## TECHNICAL BULLETIN

[Issue No.] T11-0008

[Title] Caution for the digital value output when an out-of-range analog value is input to the A1S68AD

[Relevant Models] A1S68AD

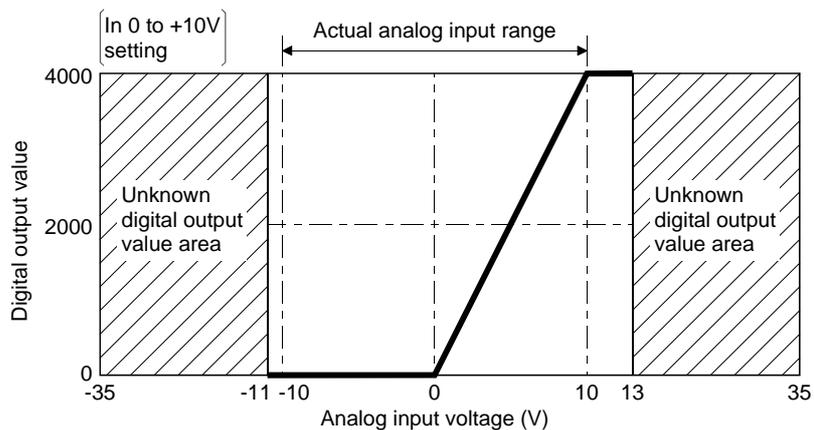
#### (1) Hardware version N or earlier

When the analog input voltage is outside a range of -11V to +13V, this result is an unspecified digital output value.

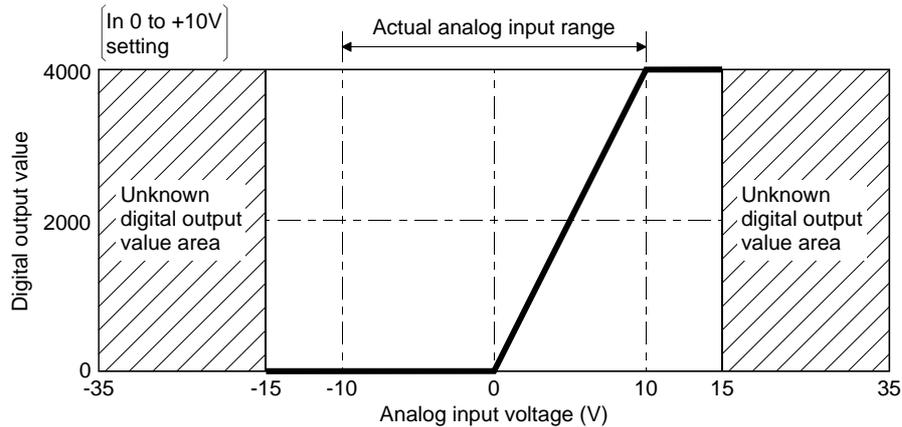
**(2) Hardware version P or later**

If the analog input voltage is outside a range of  $-15V$  to  $+15V$ , this result is an unspecified digital output value.
